City of Alexandria, Virginia

MEMORANDUM

SUBJECT: CONCEPT REVIEW OF 220 SOUTH UNION STREET
BAR CASE #2013-0321

STRAND ST (AS SUBMITTED, JUNE 2012)

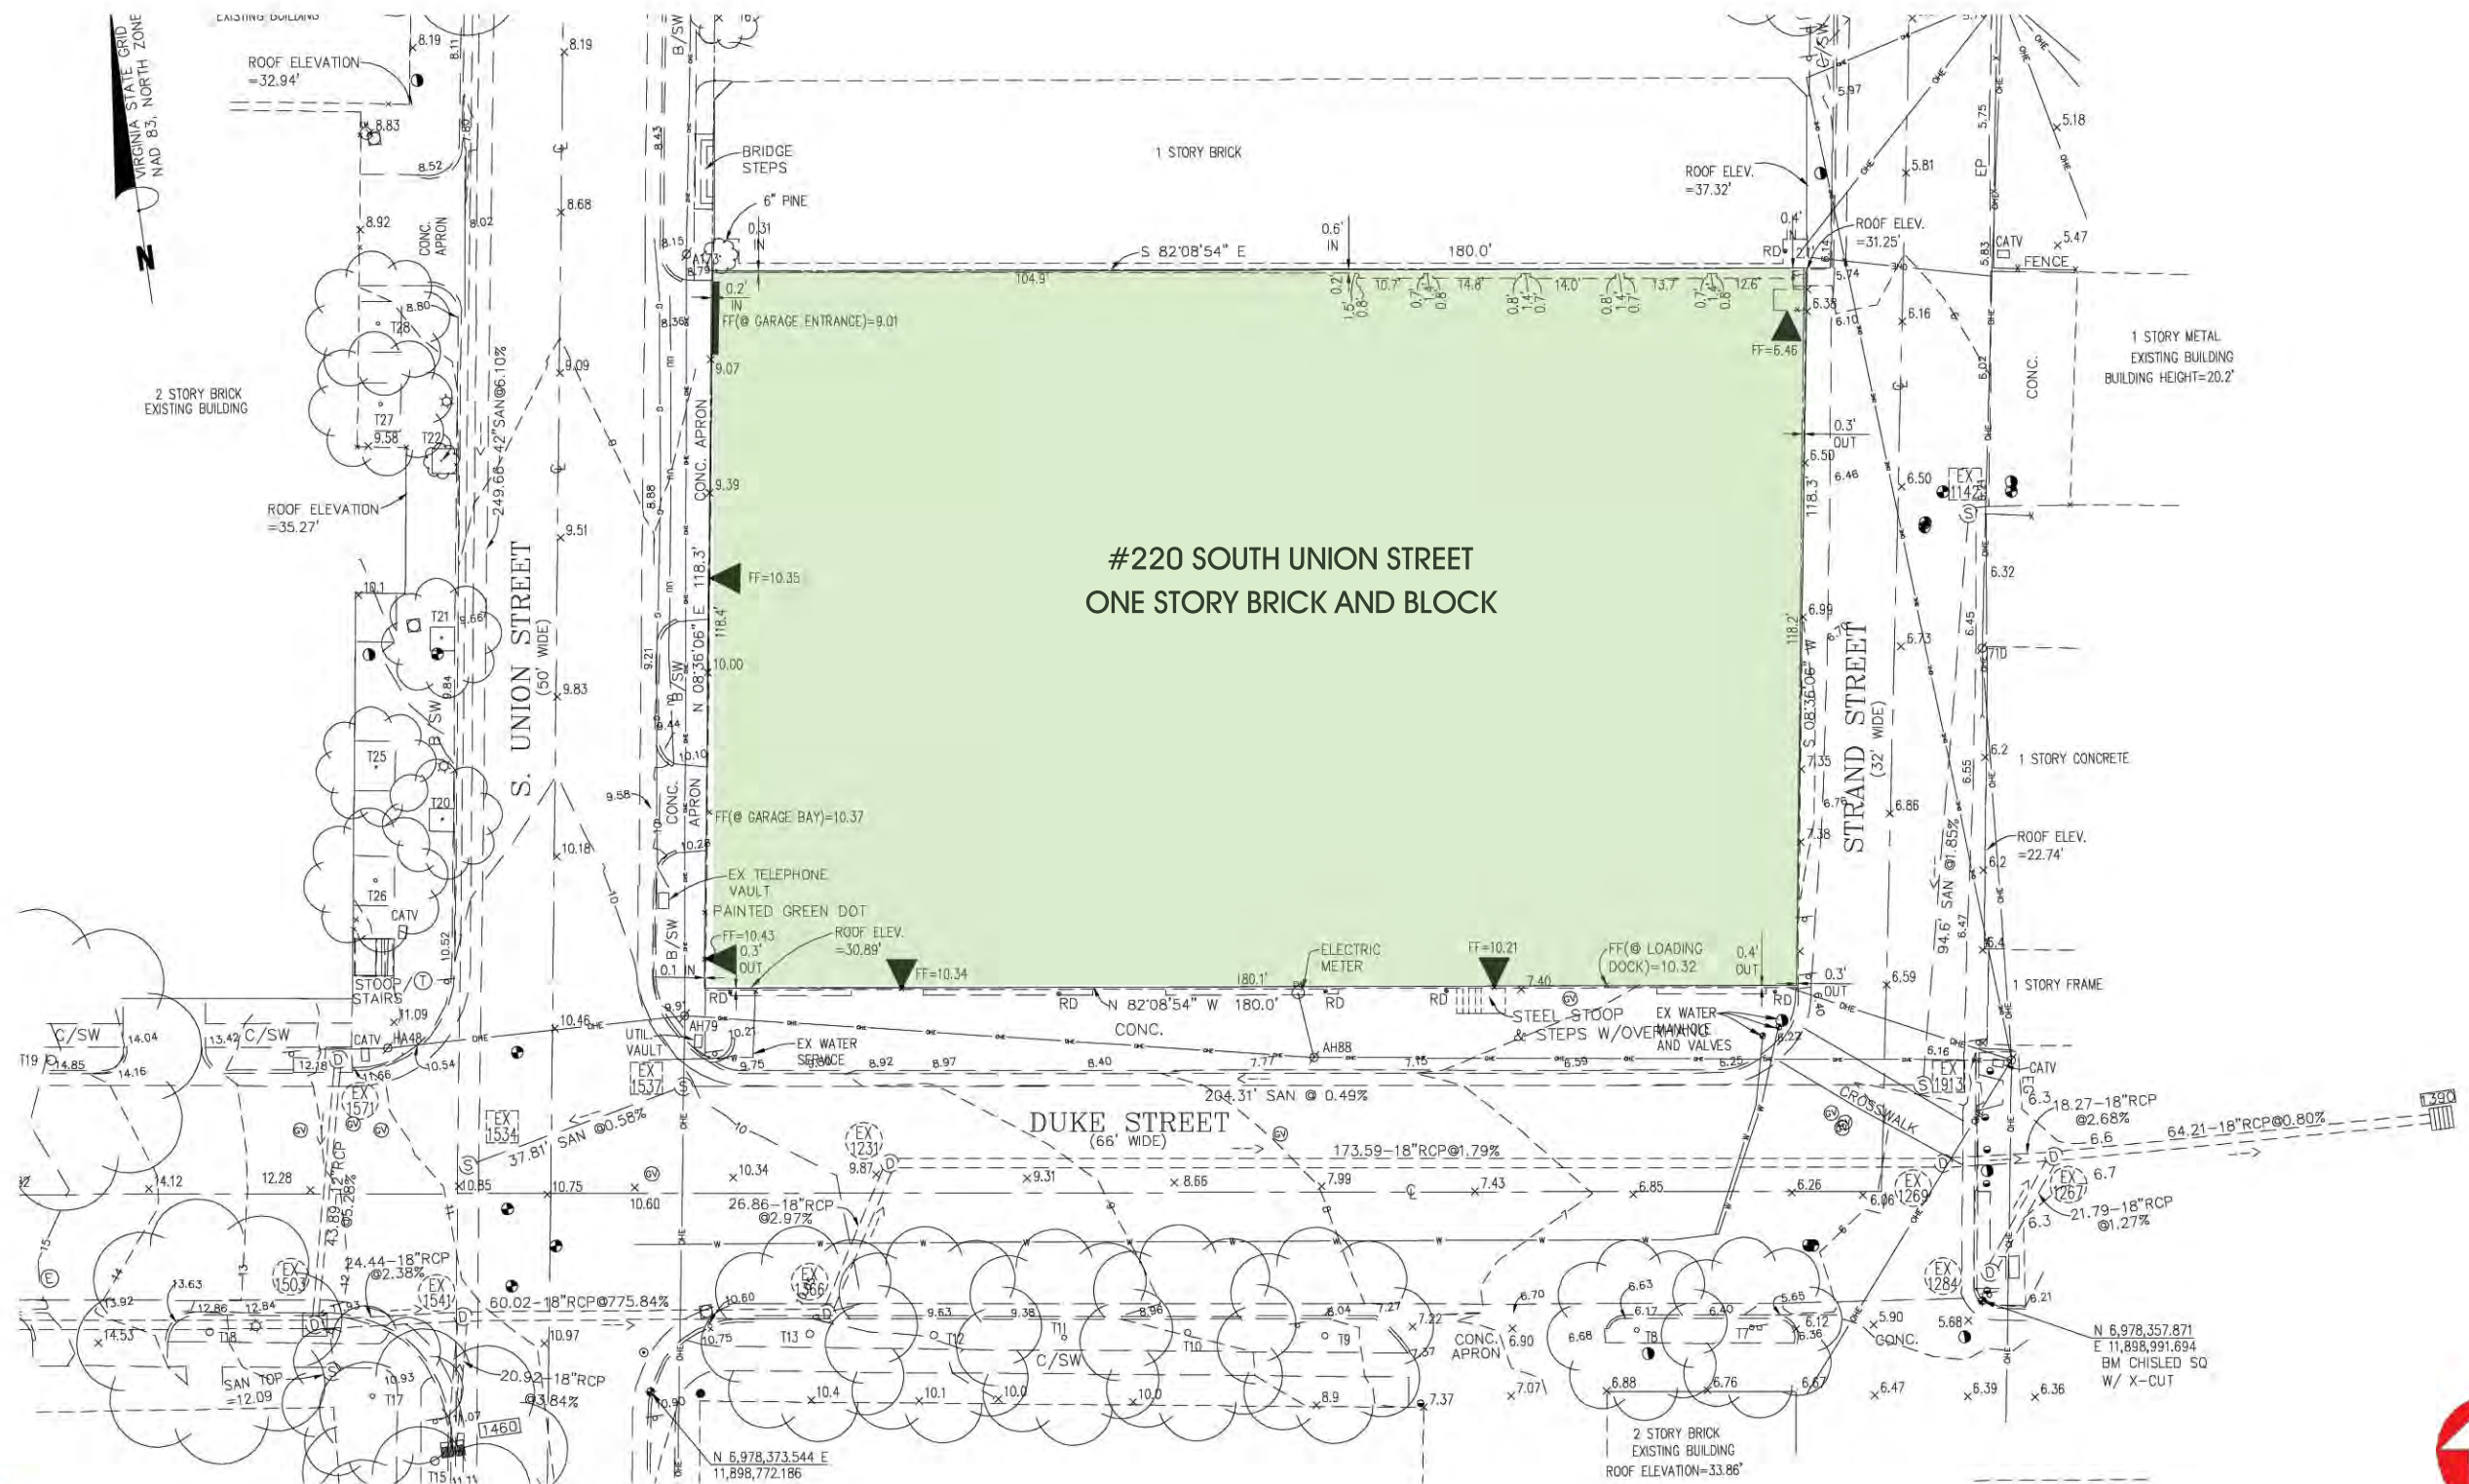
Mr. von Senden noted that there were a lot of opportunities with this project. After reviewing the project, he was not as concerned with the proposed height as he initially was and compared the proposed hotel to other buildings on the waterfront, such as the Torpedo Factory. He found the L-shaped plan to be more successful and to improve the alley sight line. He thought that the entrance should recognize cars and allow for taxis. He noted that the sense of entry was very important at this site. He liked the 7/18/12 elevation for The Strand as it reflected historic structures. He thought the storefront on South Union Street was successful. He advised keeping the carriageway light and airy or it will become problematic. On the Duke Street elevation, he found the three segments to be positive but noted that the large shed dormer on the two-story Mansard roof was not successful.

Mr. Carlin noted that the east-west circulation has always been an important aspect of the Waterfront Plan to make the blocks more porous. Throughout the planning process, he has been fascinated by the model and noted that Council's approval had a specific statement with respect to a design that reflected the model. In 1961, the City underwent a downtown urban renewal and he does not want to see the same mistakes. He suggested turning the building's L-shaped plan to make the project more integrated and have fewer problems with loading. With respect to expectations related to massing, he noted that historic warehouses in this area had up to six stories. He found the current proposal to be a big box with mid-19th-century wallpaper and he suggested added balconies at the upper stories and angling the fifth floor with dormers.

PROPOSED EAST ELEVATION

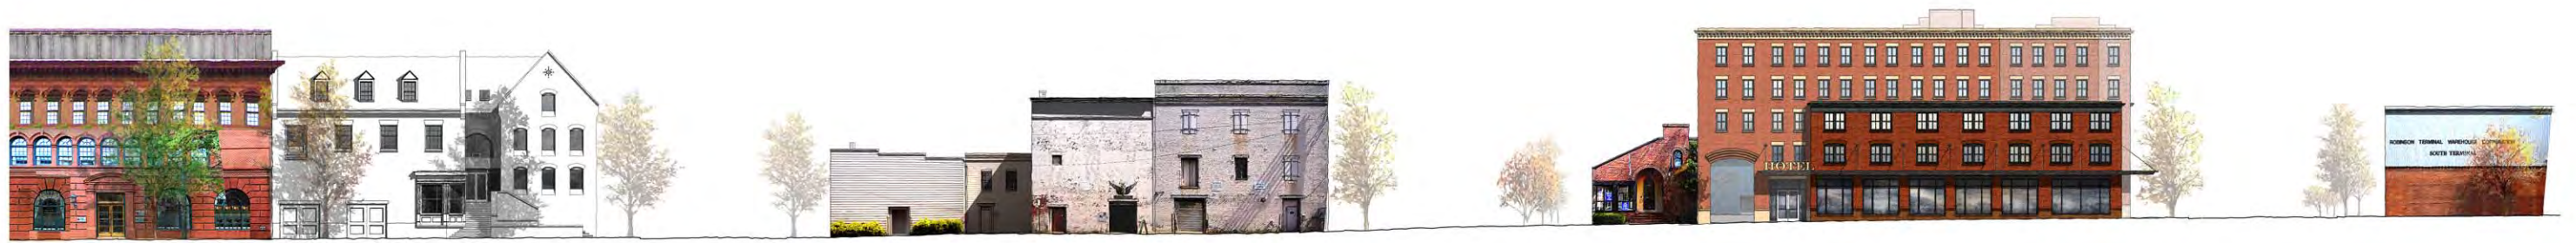
- The Strand elevation features the joining of various building elements. The center portion, marked by a pedimented parapet and two chimneys, should be revised to be more vertically proportioned and visually prominent, as it references historic warehouse forms. This can be achieved by wrapping the dark color and material around from the two-story mansard roof to the first bay on The Strand elevation or through a change in material (Kalwall or galvanized metal siding) for the three-story “wings” on this elevation, creating a distinct, lighter element.
